IloT Product End-of-Life Notice

End of Life, Last Time Buy and Replacement Announcement

For immediately release, Advantech is announcing the End of Life (EOL) of **ADAM-4060-E**. The relative replacing models are as below list. Customers who had purchased this Part Number either to purchase any additional rules or migrate to the new replacement models if possible before the EOL's shipment date.

End of Life Product	Suggest Replacement Product	Sample Available Date
ADAM-4060-E	ADAM-4060-F	Available in 2022/07/15

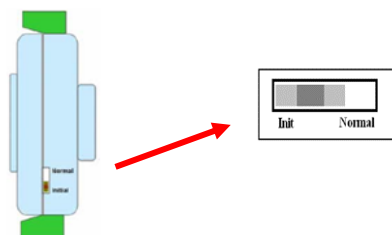
Replace the key component TI MCU 1400006109-01(MSP432P401MIRGCR) with new MCU, because MSP432P401MIRGCR L/T is longer than 371 days.

Impact	New version
Pin assignment	Backward compatible
Hardware spec	Backward compatible
FW	New version A 4.00 or later
Utility	Adam/Apax .NET Utility 2.6.00 B15 later version

1. Enable data format settings (parity none/odd/even, stop bit 1/2) for ADAM ASCII protocol
2. Add Initial switch
